Addendum No. 1

City Project No. 20-013 “Water and Sewer Main Extensions Golden State Blvd.”

April 26, 2022

PLATE NO: 3-H2

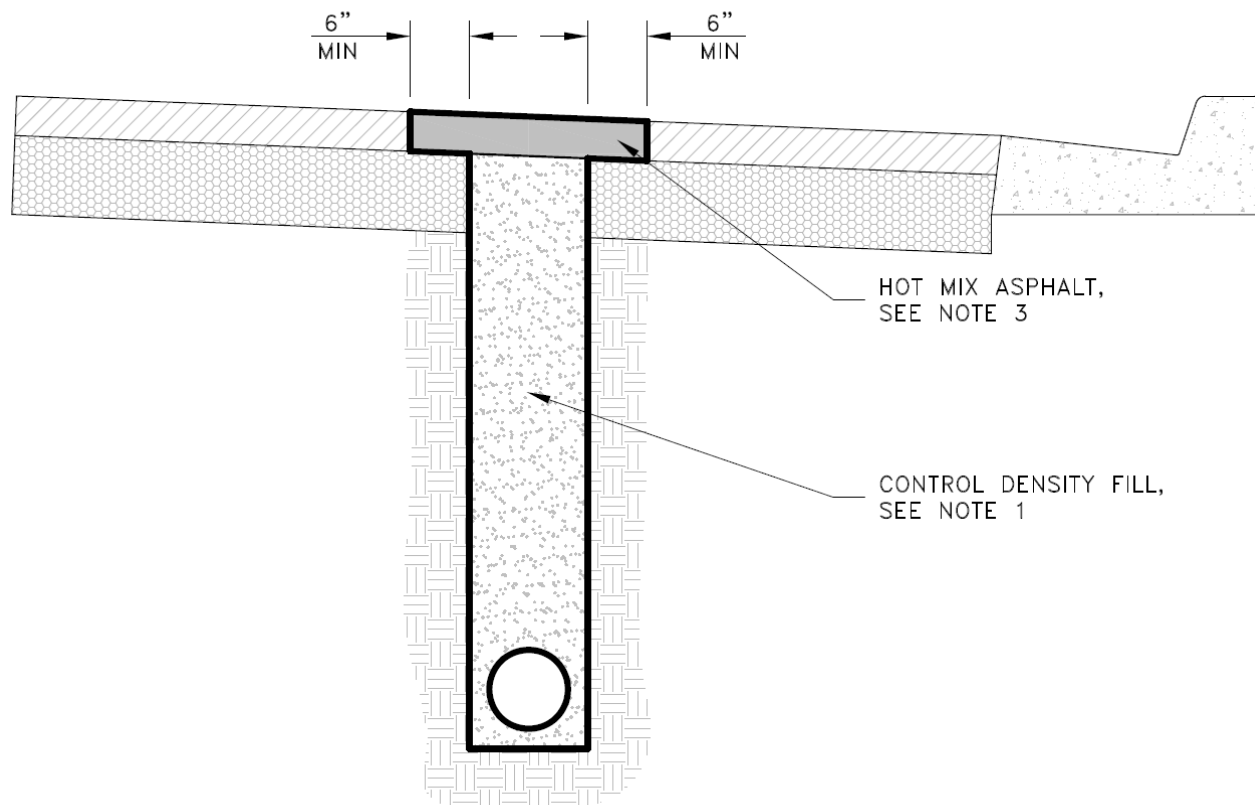
Add the following Stanislaus County Standard Drawings (see attachments to this addendum):

- 3-H2 "Trenching Requirements in Existing Streets"
- 3-H3 "Potholing for Design and Construction"
- 3-H4 & 3-H5 "Trench Construction Notes"
